Architectural Review and
Historic Preservation Board
Agenda Report

Meeting Date 06/02/2021

File: AR 20-18

RE: Architectural Review 20-18 (AMPM Gas Station);
A portion of APN 006-690-022

This document, the ideas and designs incorporated herein, are solely the property of VAI and is not to be used, in whole or in part for any project or duplication, without written authorization. © COPYRIGHT 2020

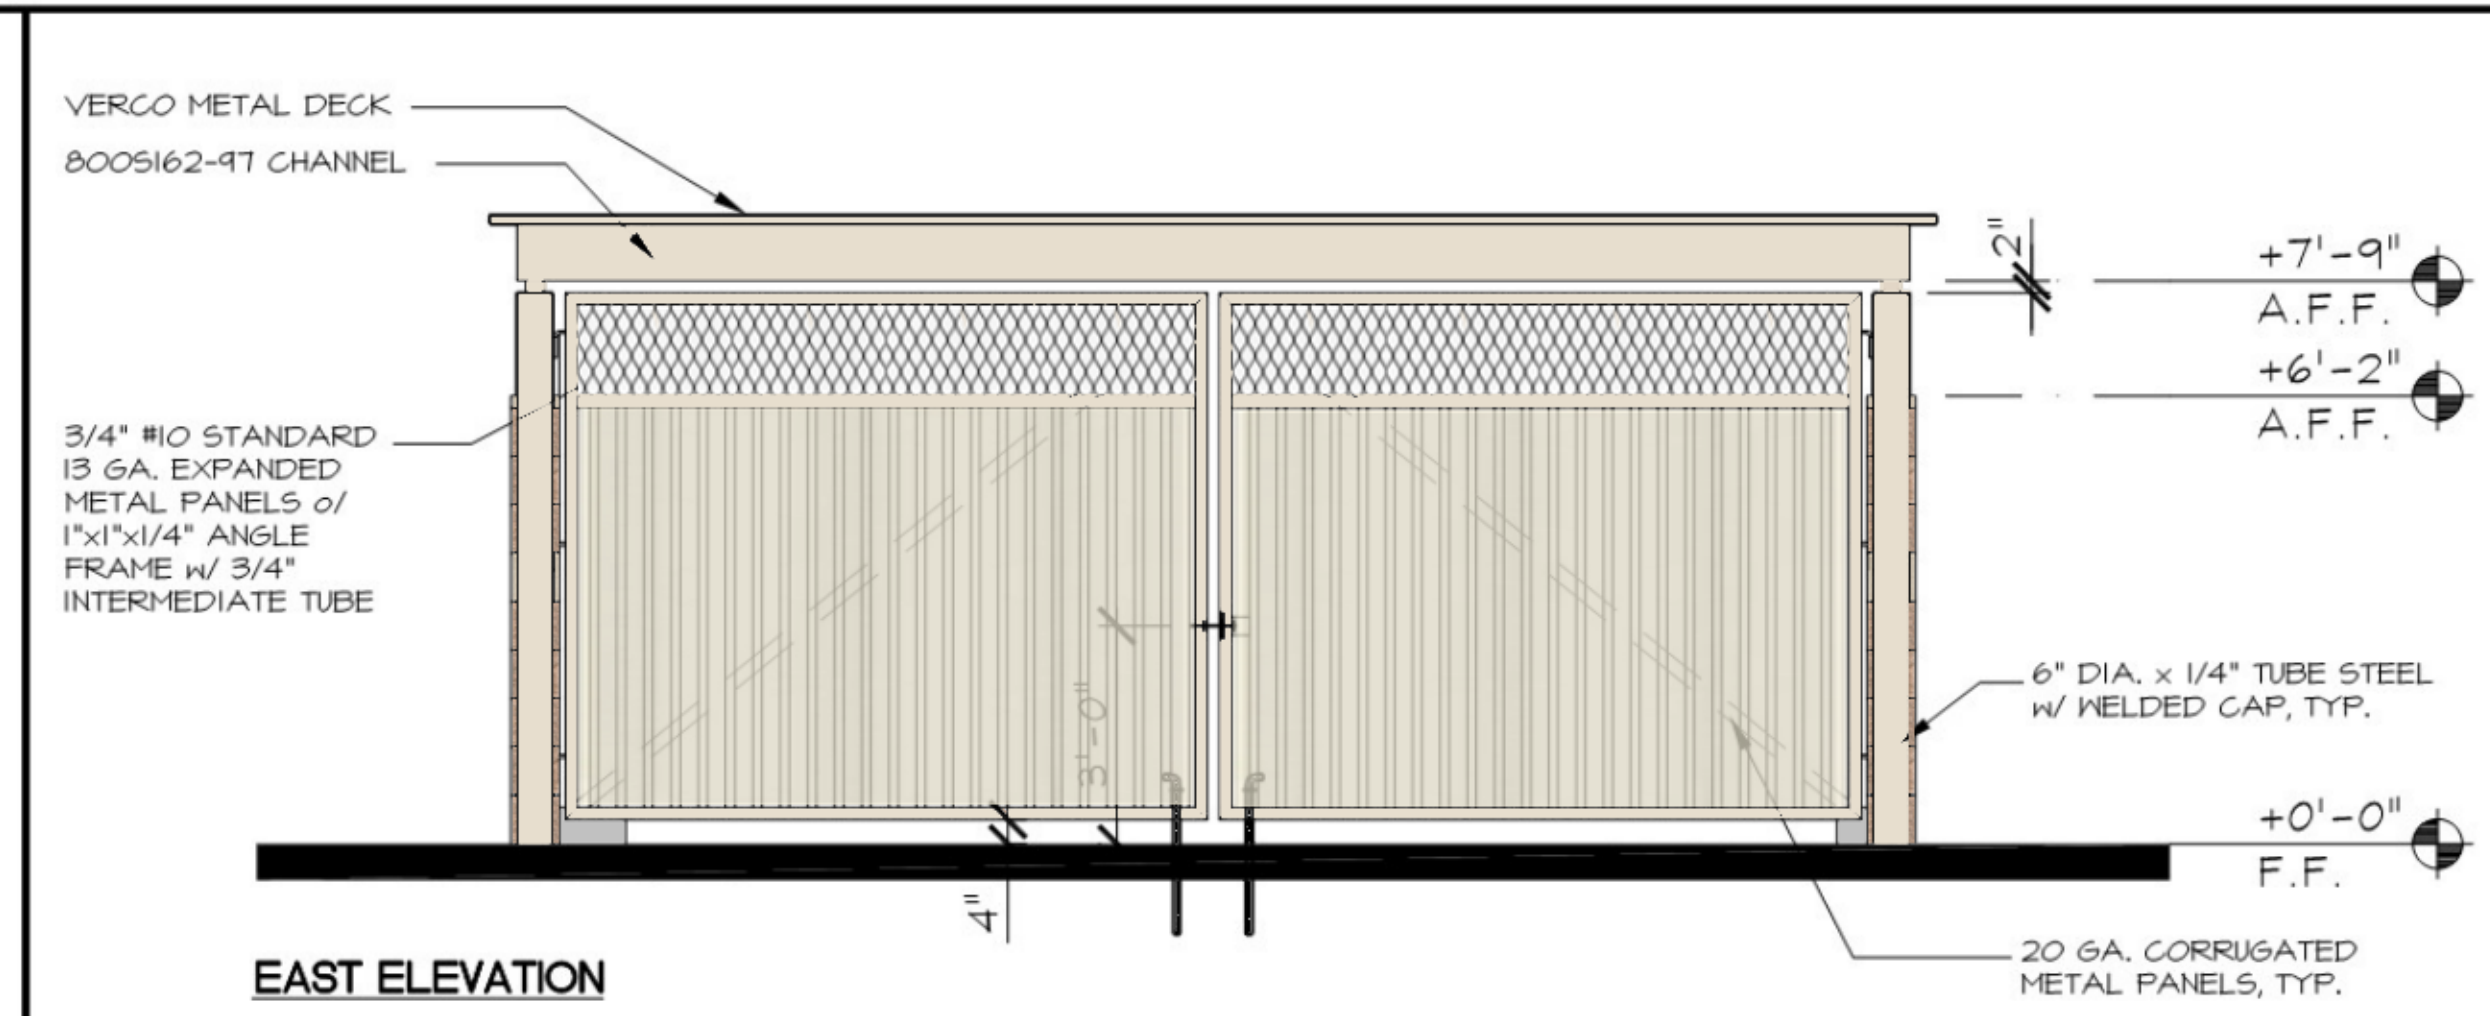
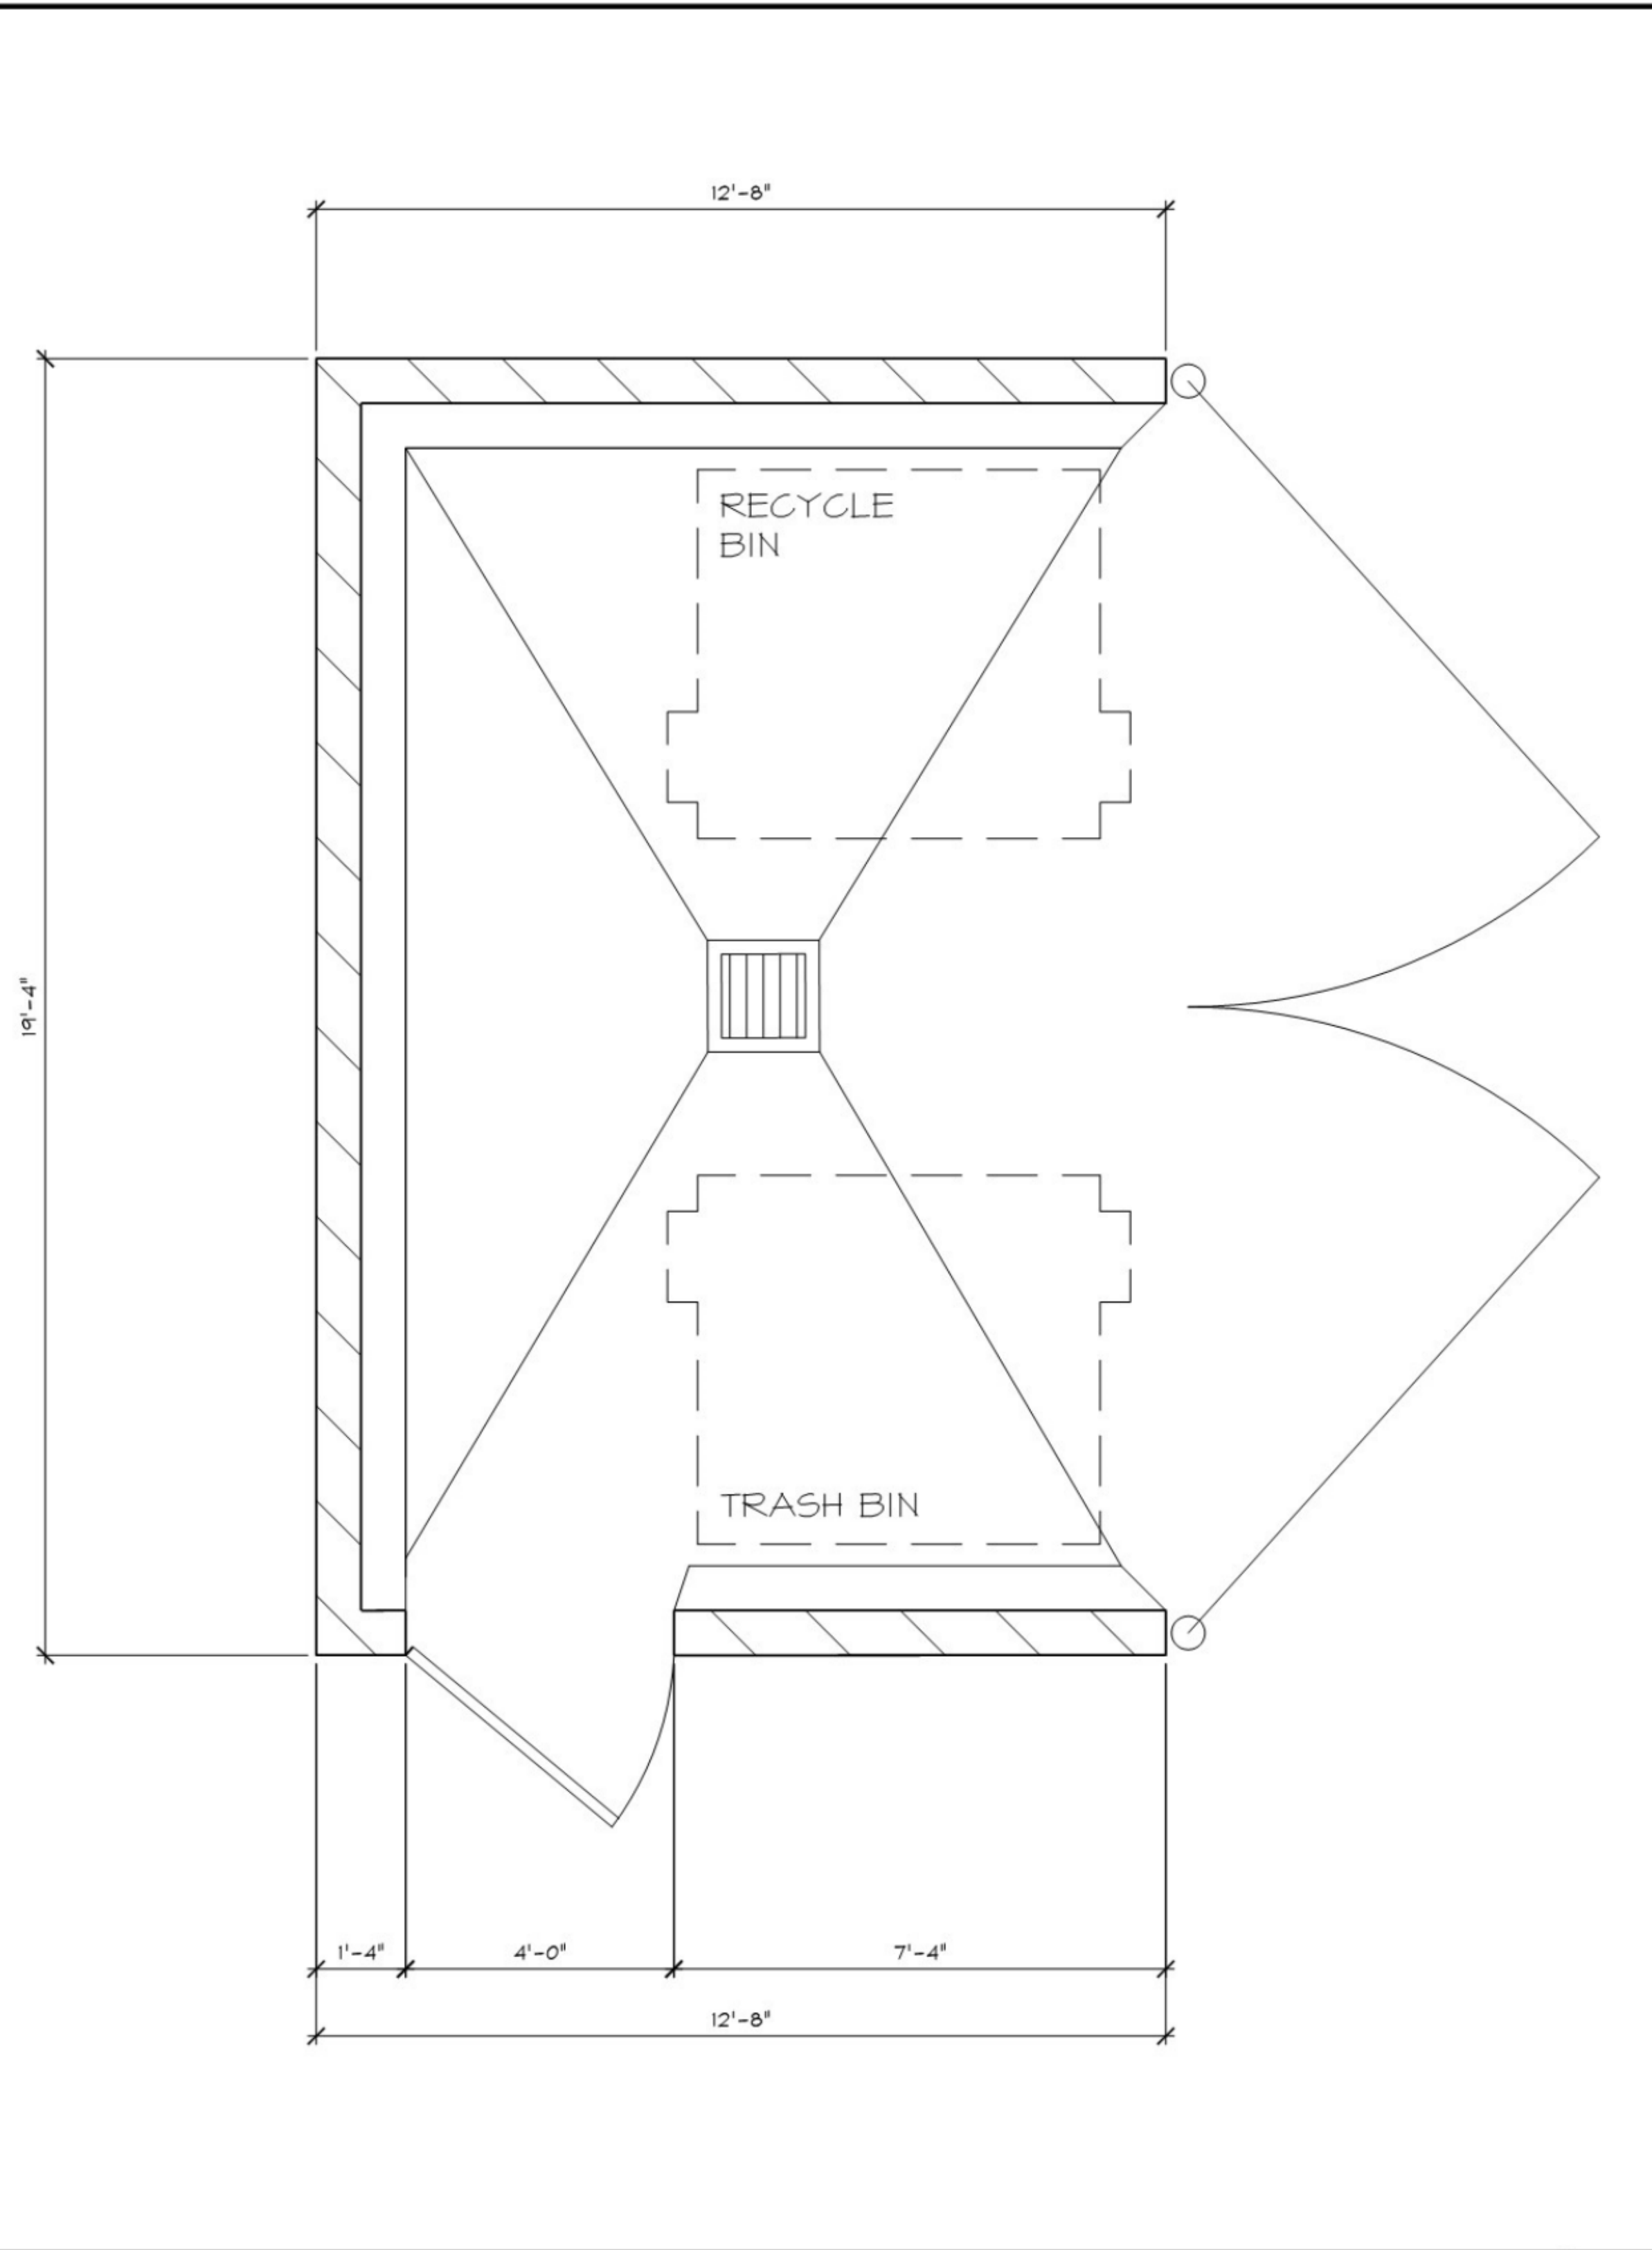
6. Wall-mounted trellis panels with climbing vines shall be incorporated on the rear (south) and east side elevations of the proposed convenience store building, and on the north side of the trash enclosure. These features shall be shown on the final landscaping plan to be submitted with building plans.
